JWP/TS/DP1431

6th October 2006

11-13 GOODGE STREET, LONDON, W1

Further to our meeting on 29th September to discuss design comments in relation to planning applications 2006/3769/P, we have considered the issues raised and set out the amendments to the application below. Our clients have made significant alterations to the proposals and have addressed all the issues raised.

11 - 13 GOODGE STREET
PROPOSED FOURTH FLOOR PLAN
PLANNING
440_02_07_105

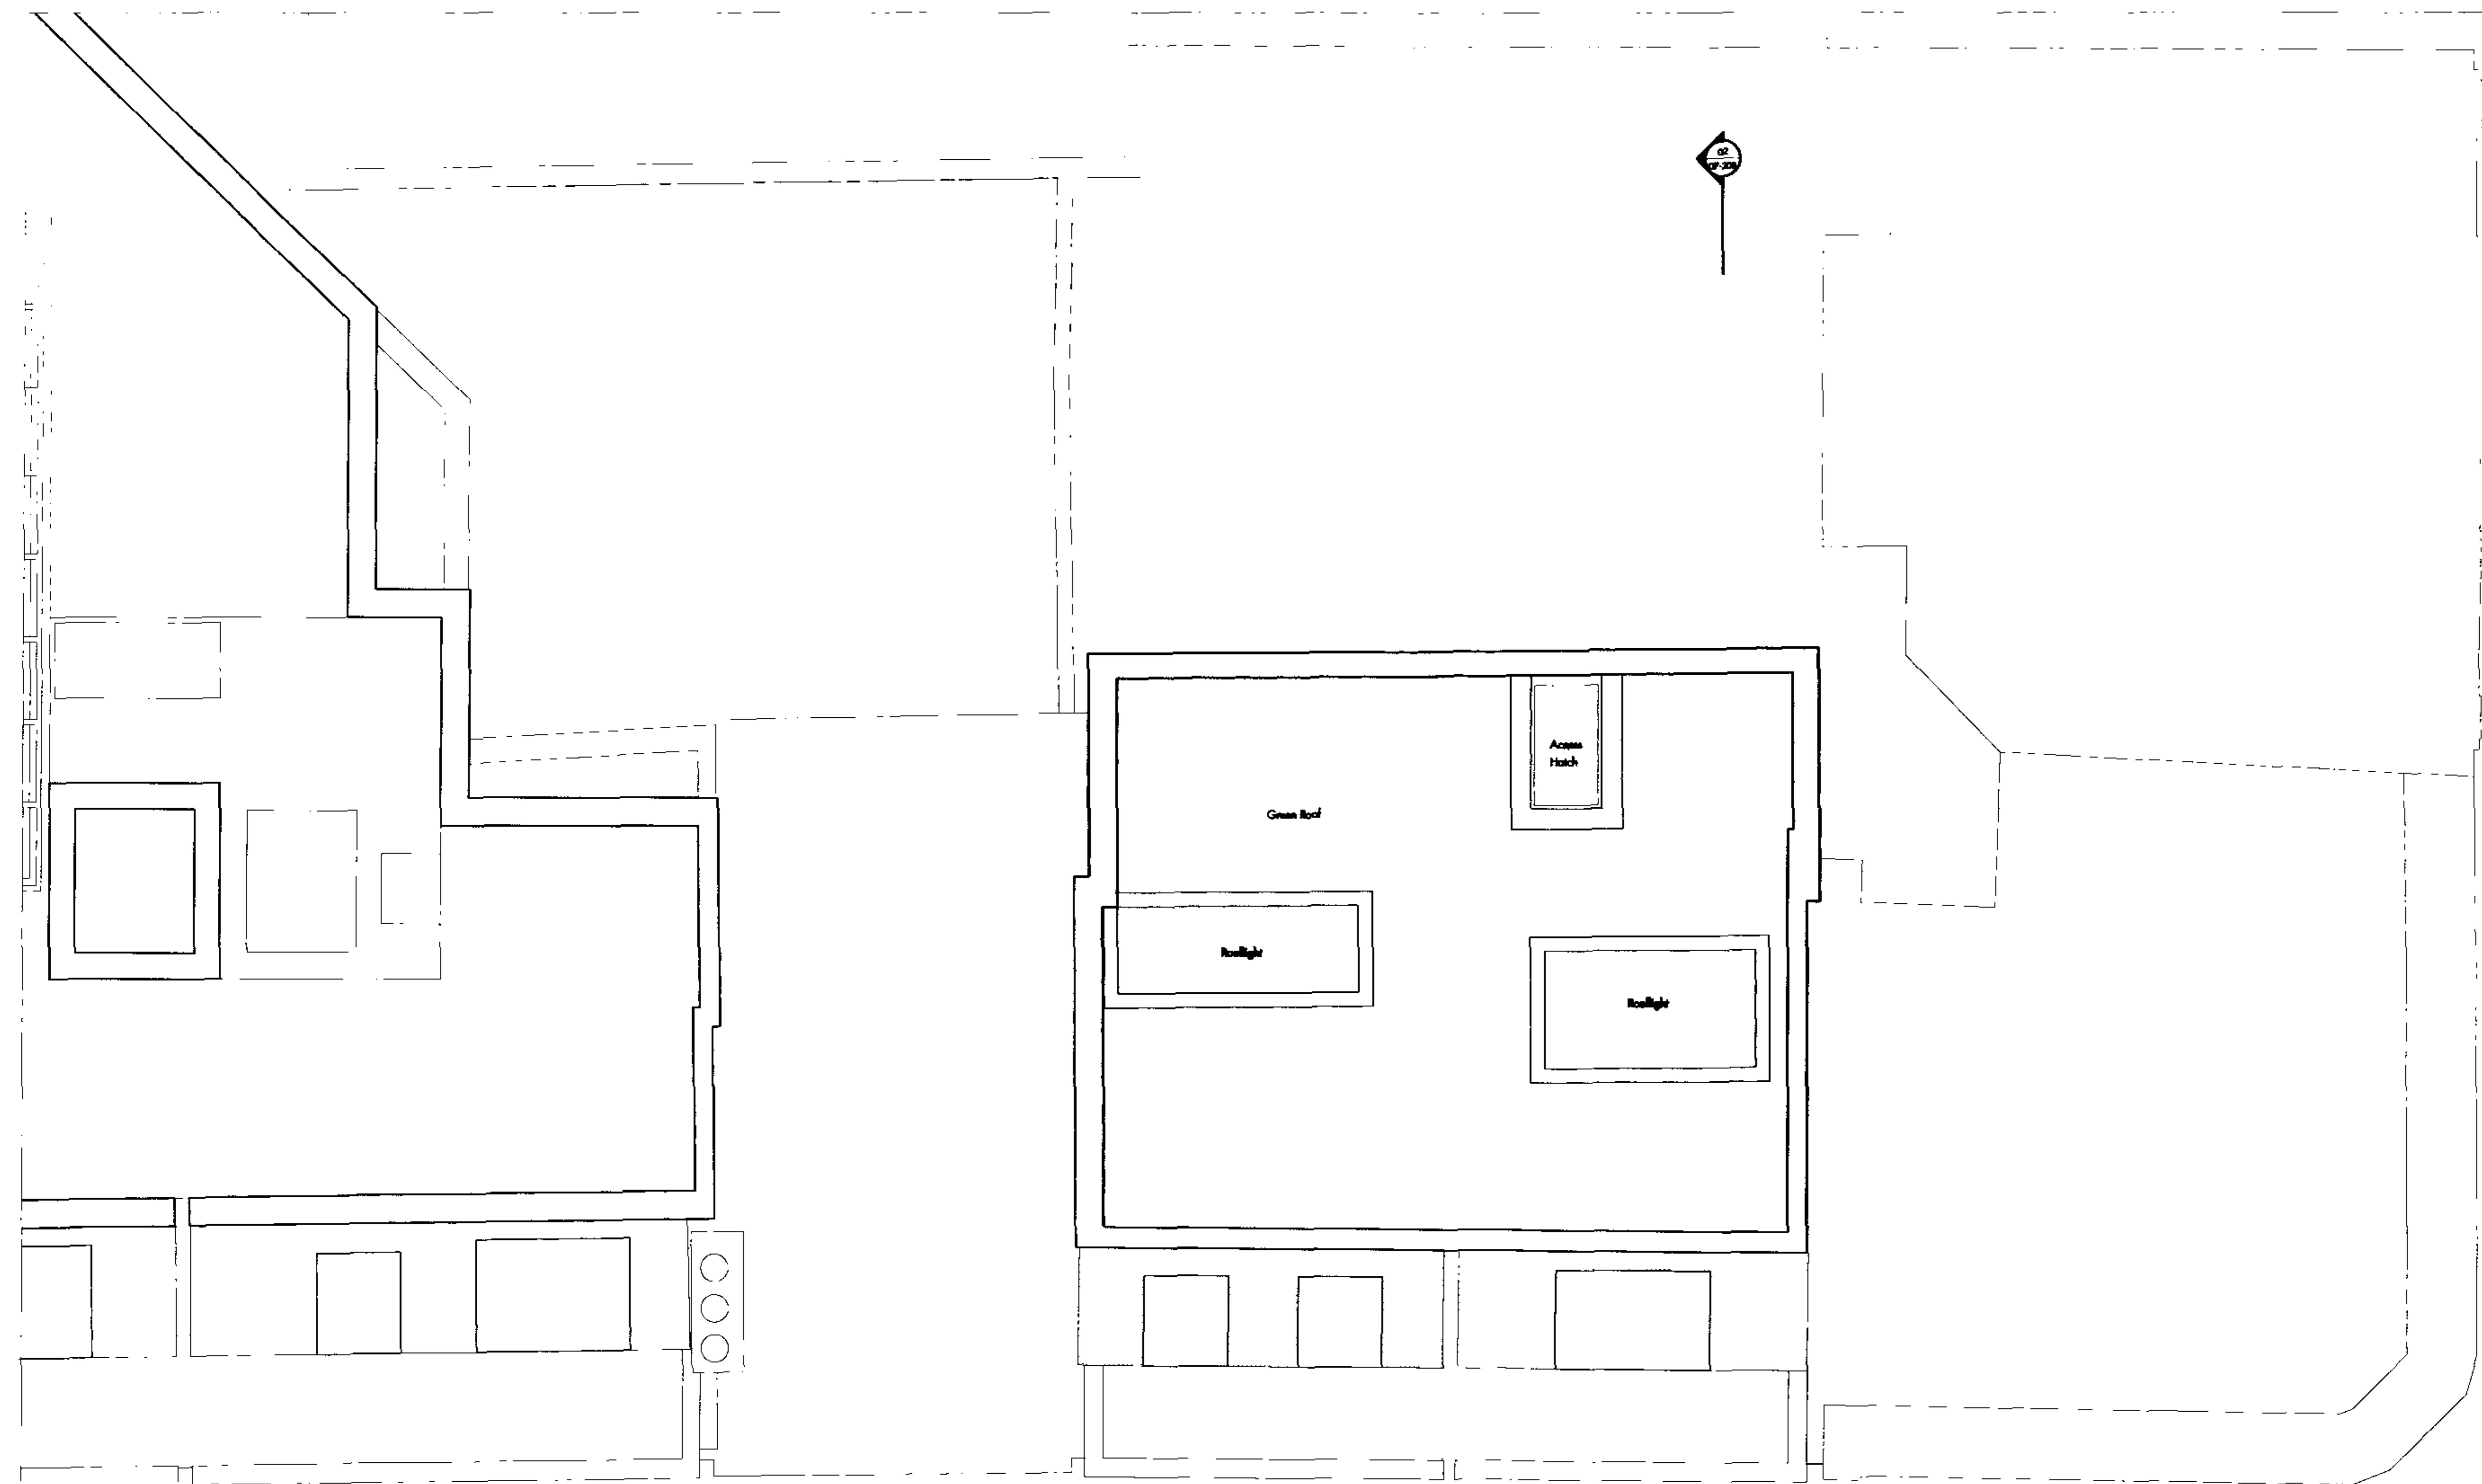
Provision of a 3 bedroom unit

As requested, a 3 bedroom unit has been accommodated with the development. This has resulted in a change to the unit mix, with 6 x 1 bedroom units and 1 x 3 bed unit, with all units meeting the Council's minimum room sizes.

The new fourth floor layout is shown on revised plan 440_02_07_sk105 Rev A. As agreed, a sketch drawing has been provided with the completed drawing sent to the Council early next week.
